**SAN ANTONIO WATER SYSTEM**  
**NORTHEAST SERVICE CENTER – PARKING LOT ADDITION**

**SAWS JOB NUMBER #12-7701**  
**SAWS SOLICITATION #B-12-038-DD**

**ADDENDUM NO. 1**  
**June 22, 2012**

Project No.: 28722  
 Issued: JUNE 2012  
 Drawn By: CC  
 Checked By: BWL  
 Scale: AS NOTED  
 Sheet Title  
 PAVING DETAILS  
 C1.25  
 Sheet Number

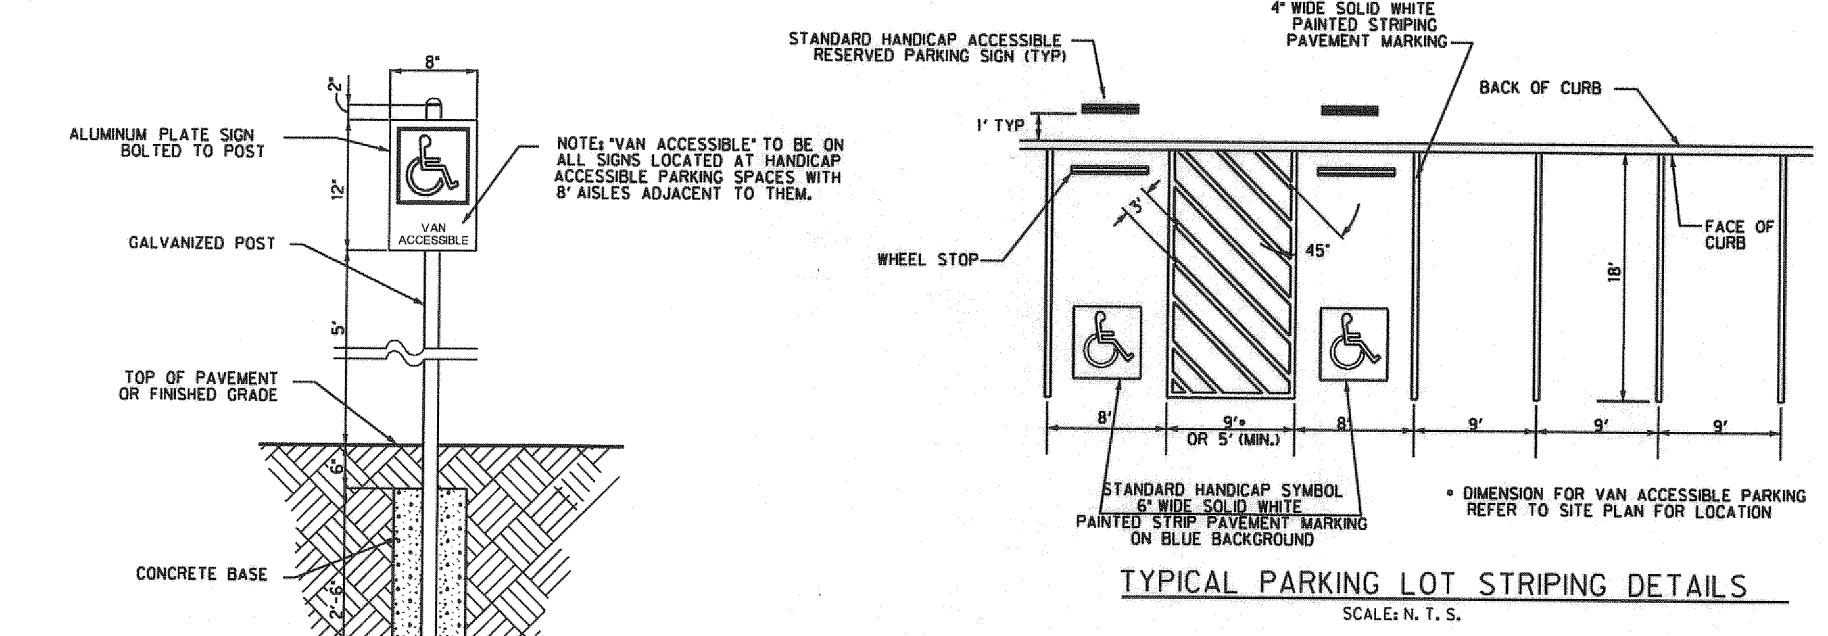
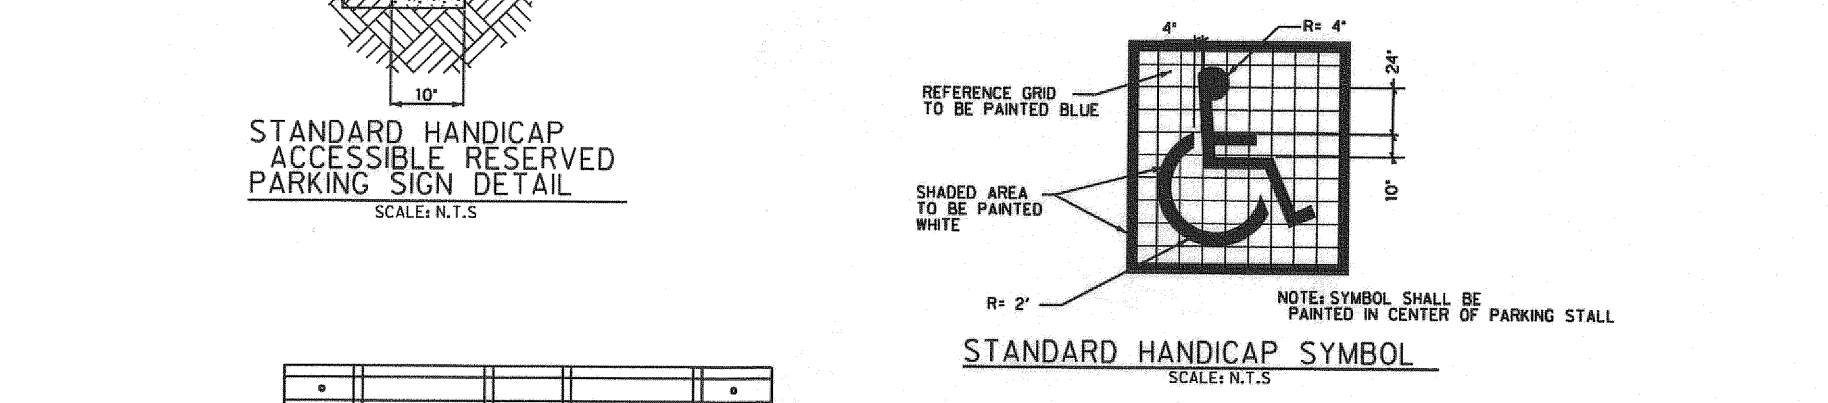
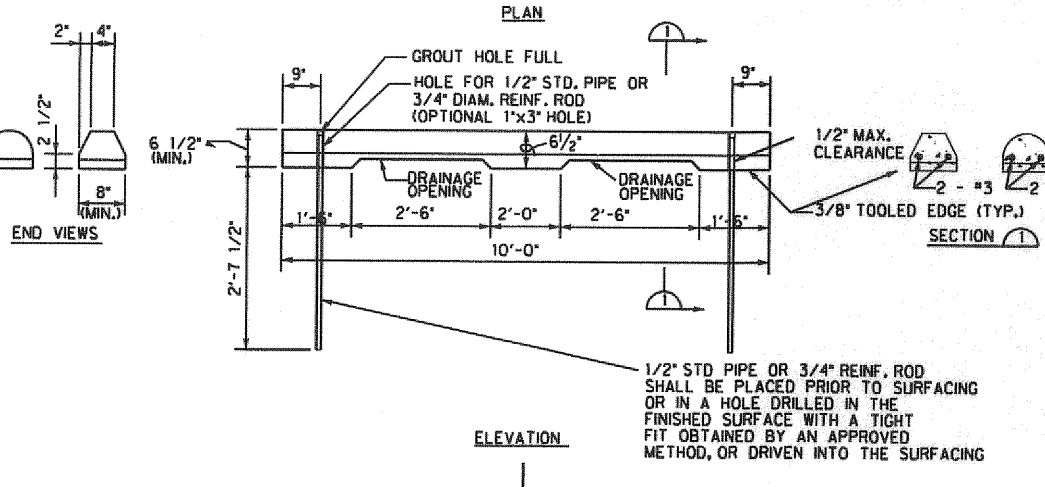
**Sheet C1.25**

"Added removable bollards detail, handicap spot details and wheel stop details."

**C1.28**  
Sheet Number

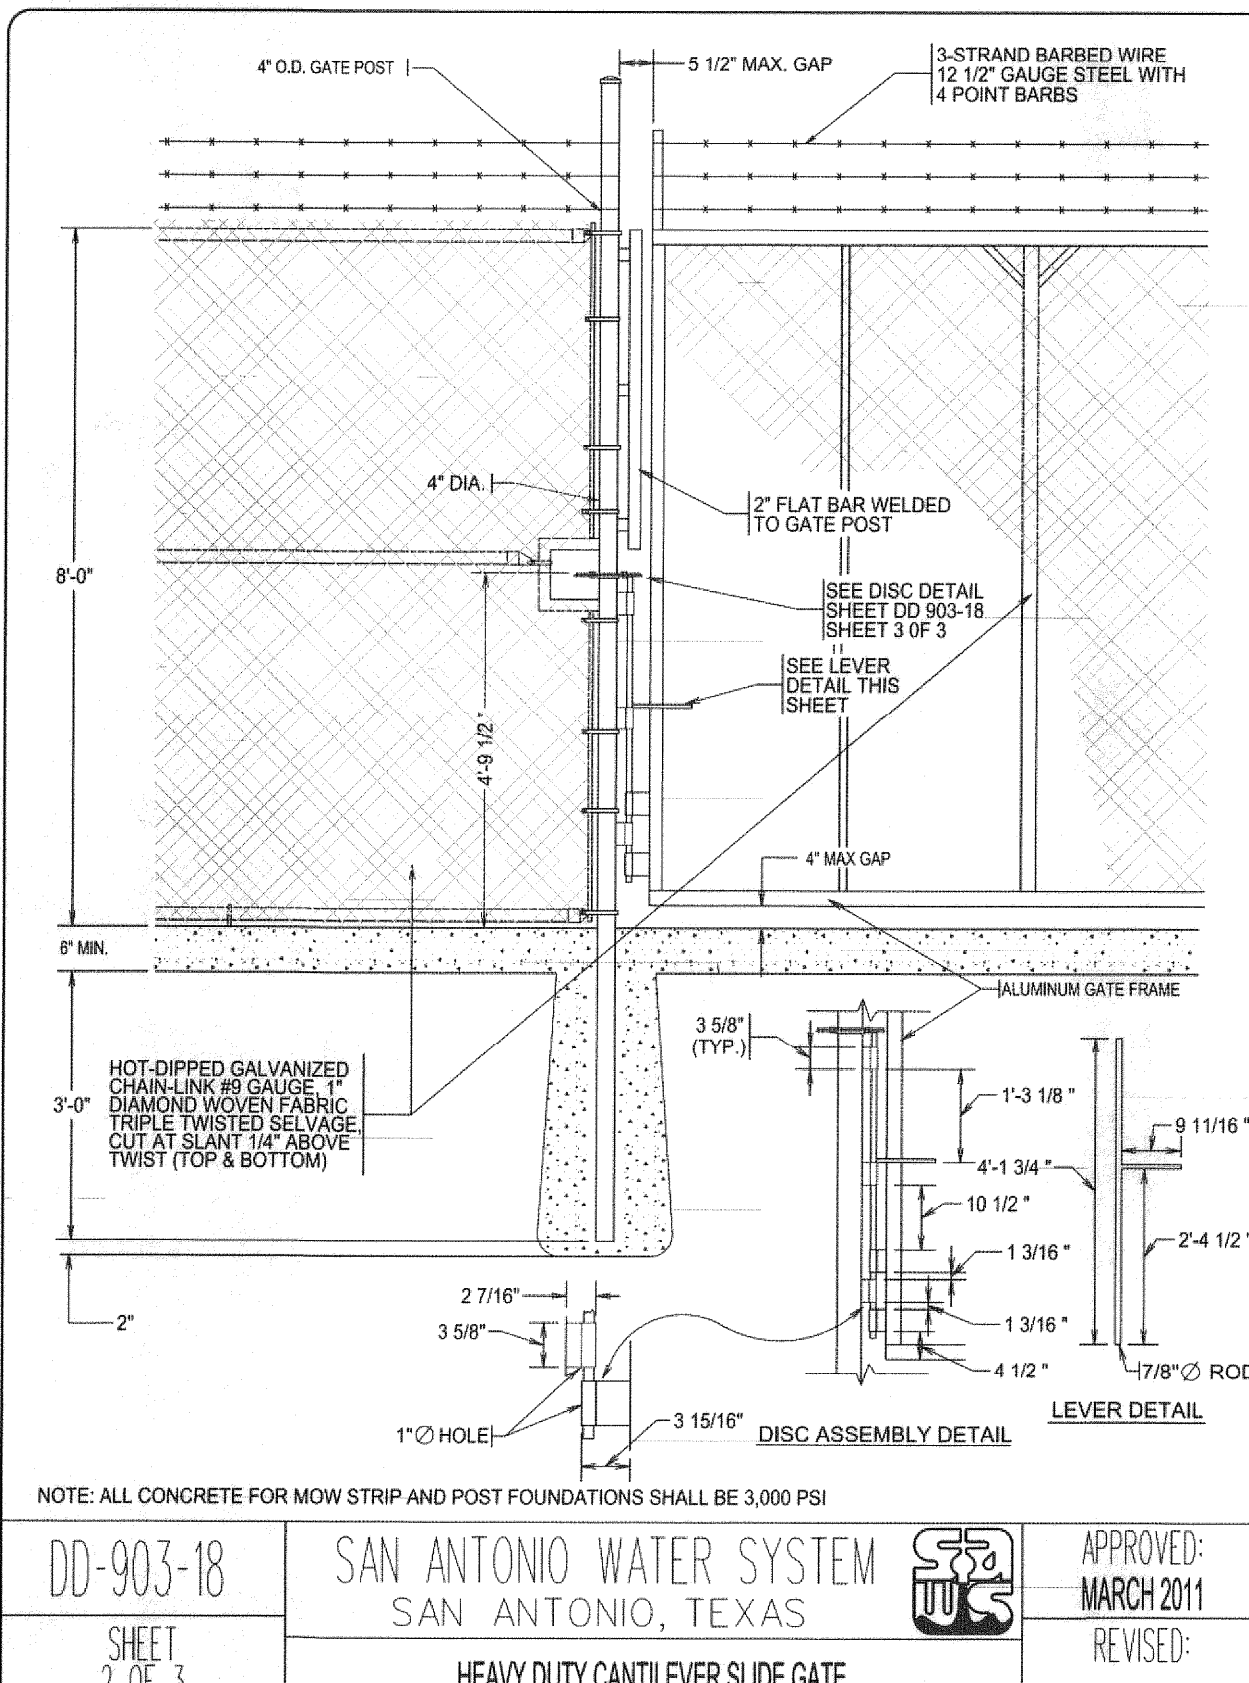
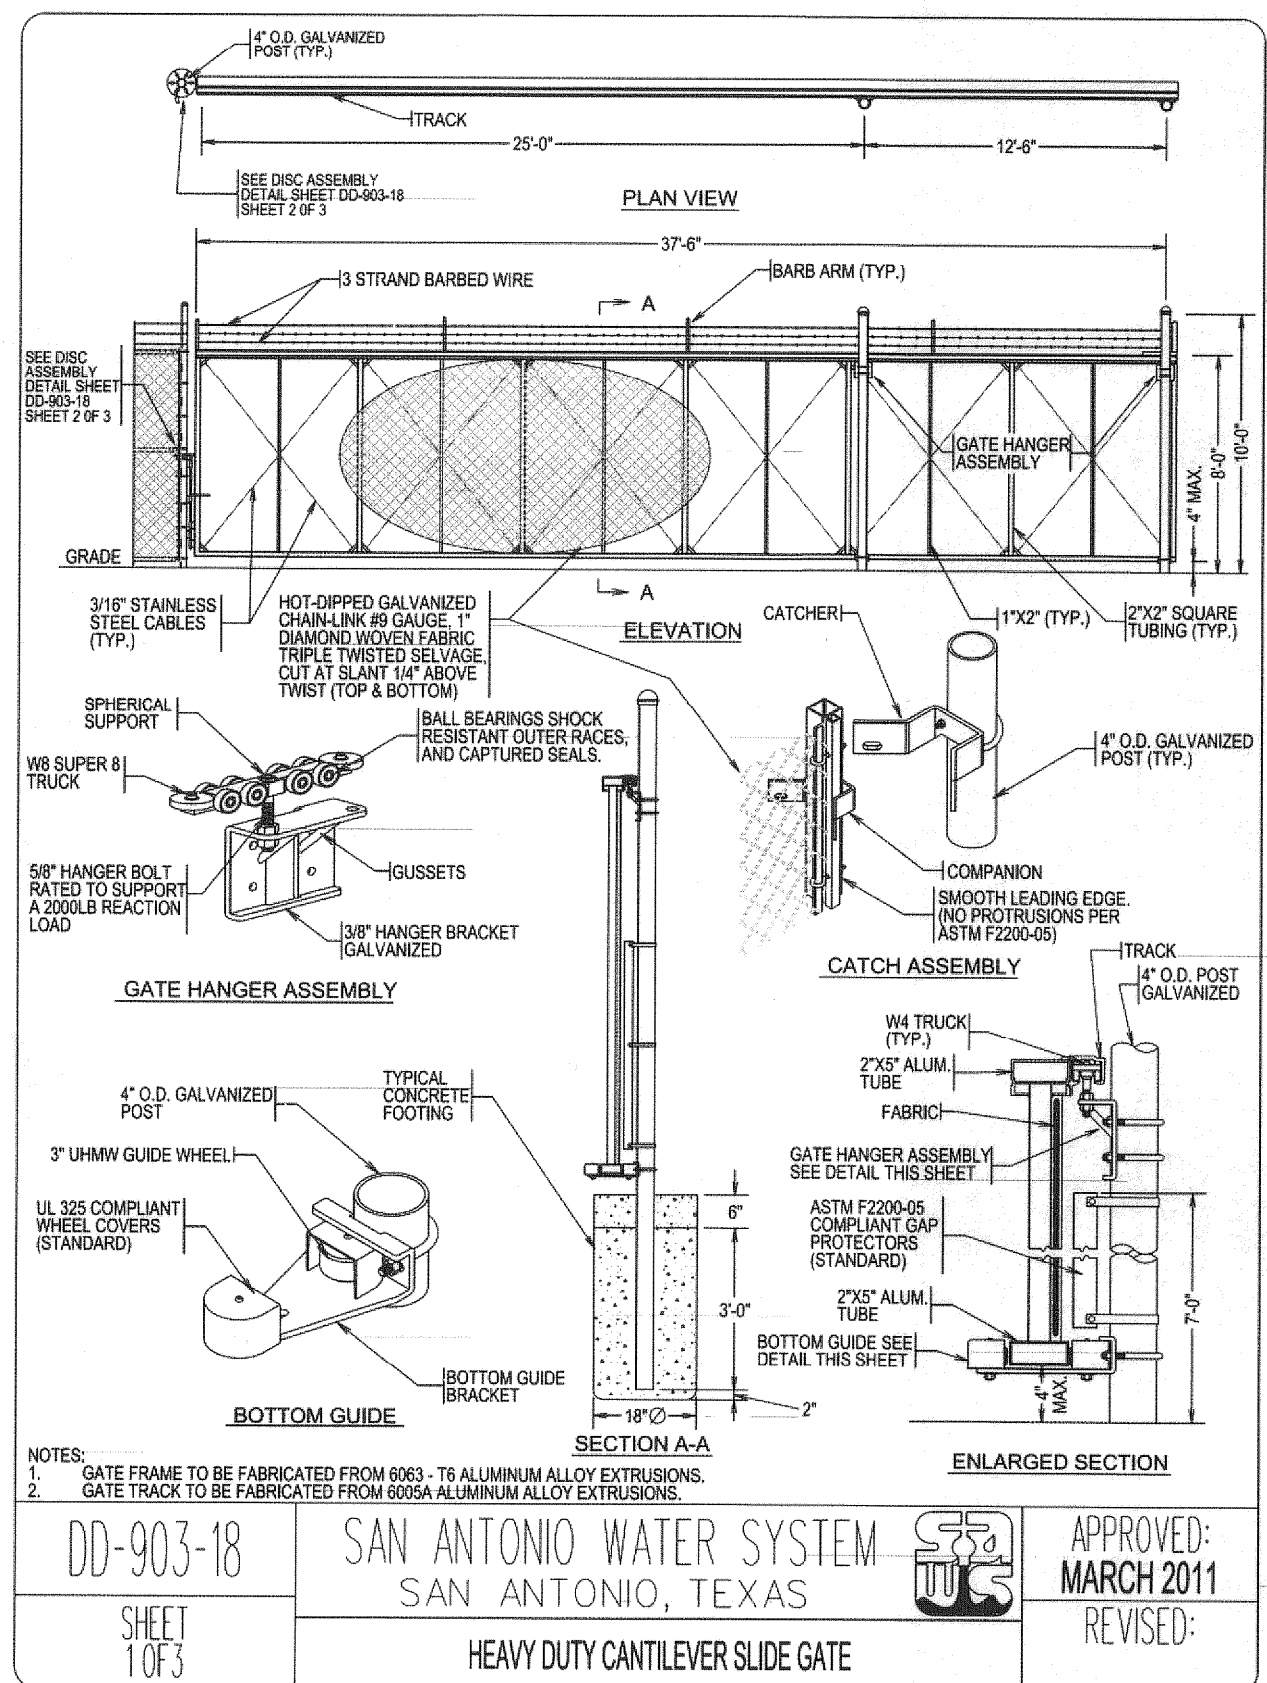
**Sheet C1.28**

"Added the following notes."

1. CONTRACTOR SHALL CONTACT SAWS FOR APPROVAL OF DESIGN OF LETTERS AND SAWS LOGO TO GO ON SIGN PRIOR TO FABRICATION AND INSTALLATION. SAWS HAS USED "SIGN SPOT" PREVIOUSLY LOCATED AT: 1150 N. LOOP 1604 #108-559, SAN ANTONIO, TEXAS, 78248. PH# (210)454-9545. THIS SIGN CAN BE BUILT BY ANY SIGN COMPANY AS LONG AS THE DESIGN IS APPROVED BY SAWS.

2. METHOD FOR ATTACHING SAWS LOGO AND LETTERS TO THE WALL SHALL BE APPROVED BY SAWS PRIOR TO INSTALLATION. METHOD FOR ATTACHING SAWS LOGO AND LETTERS SHALL BE BASED ON THE SIGN MANUFACTURE'S RECOMMENDATIONS.

3. CONCRETE FOR FOUNDATION AND WALL SHALL BE A MINIMUM OF 3,000 PSI CONCRETE.
4. MASONRY VENEER FOR MARQUEE SIGN SHALL BE CONSTRUCTED ACCORDING TO ACI 530.1.

5. BRICK: ASTM C216 OR C652 GRADE SW, CORED BRICK.
6. MORTAR: USE TYPE S PORTLAND CEMENT AND LIME OR MORTAR CEMENT. CONTRACTOR TO ENSURE PROPER BOND BETWEEN THE BRICK AND THE CONCRETE WALL.

7. GROUT: SHALL BE 2,500 PSI POURED AT 8" TO 11" SLUMP. GROUT SHALL CONFORM TO ASTM C476 SPECIFICATIONS.
8. BRICK PATTERN WALL SHALL BE A RUNNING BOND PATTERN.

16. Please provide a masonry selection & specification for the Marquee Sign Wall shown on sheet C1.28.

17. Please provide a Cast Alum Letter selection & specification for the Marquee Sign Wall shown on sheet C1.28. Advise if SAWS has a current Signage Contractor who can fabricate the approved SAWS Logo and lettering.

*Response: A note has been added to sheet C1.28 that states "SAWS HAS USED "SIGN SPOT" PREVIOUSLY LOCATED AT: 1150 N. LOOP 1604 #108-559, SAN ANTONIO, TEXAS, 78248. PH# (210) 454-9545. THIS SIGN CAN BE BUILT BY ANY SIGN COMPANY AS LONG AS THE DESIGN IS APPROVED BY SAWS" The contractor is responsible for coordinating with Sign Spot or another sign contractor for the design and specifications of the sign to be approved by SAWS.*

C1.30  
Sheet Number

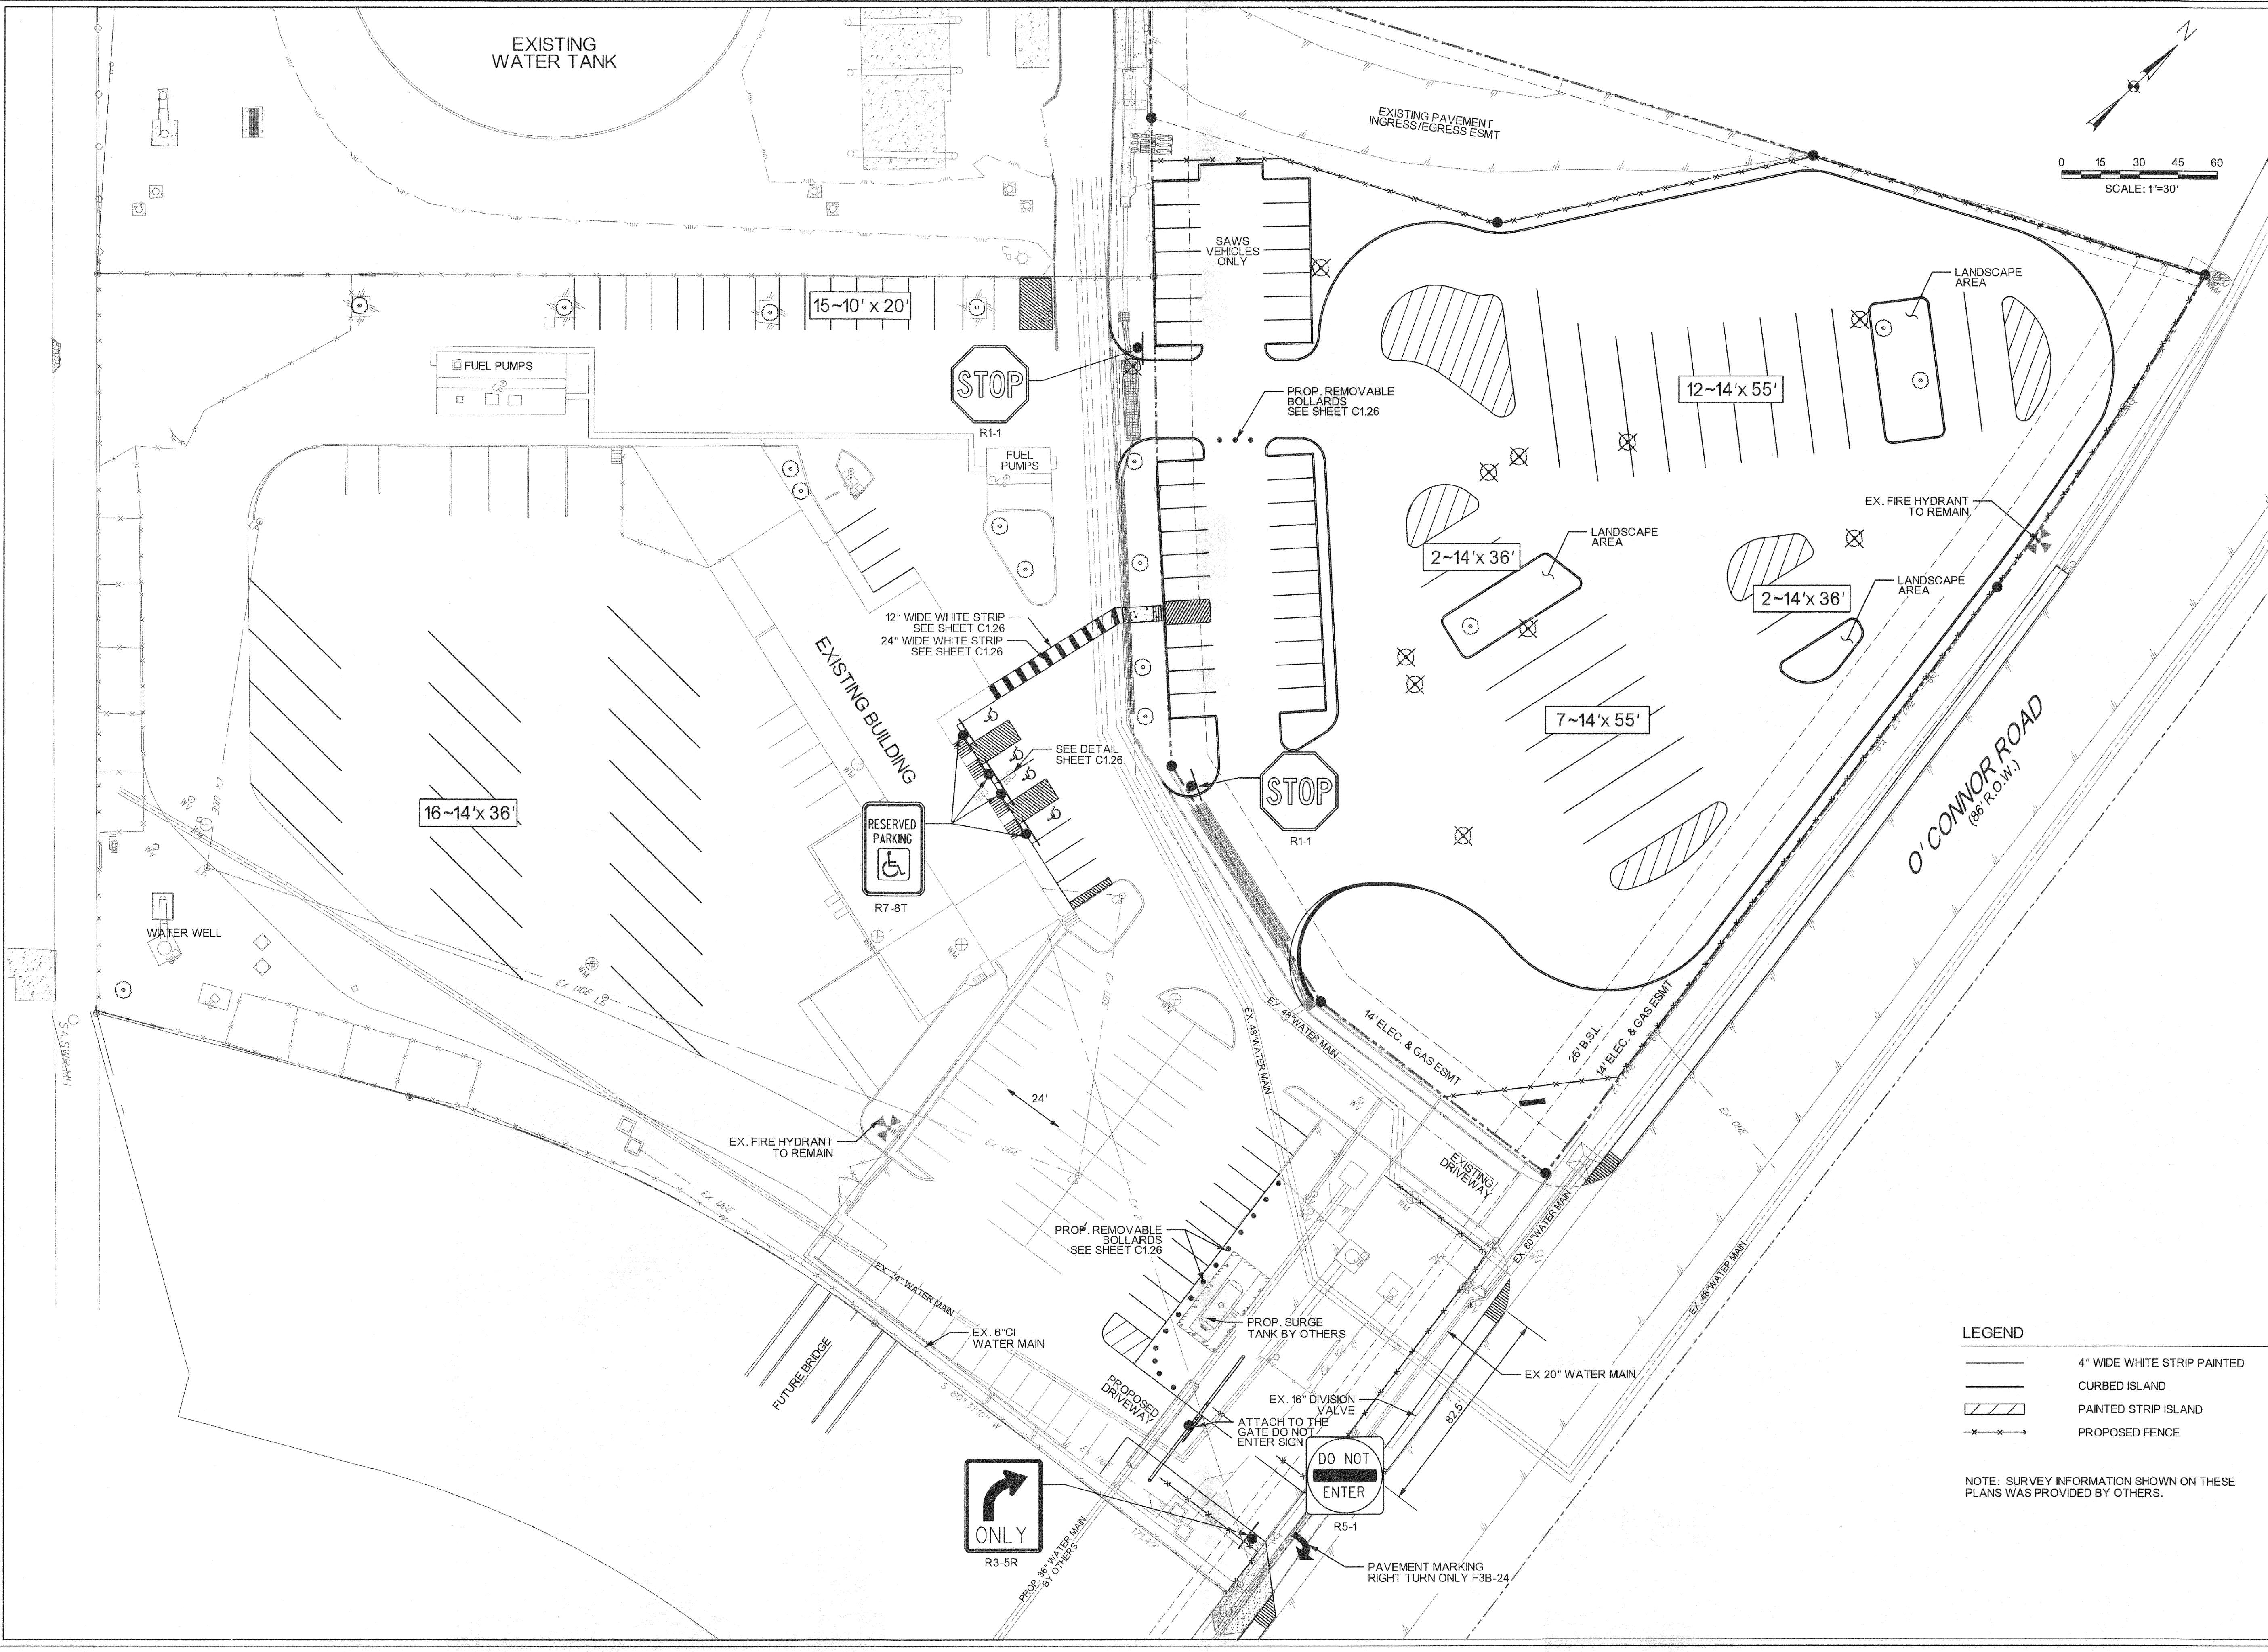
**Sheet C1.30**

"Added new sheet C1.30 'Striping and Signage Plan'."
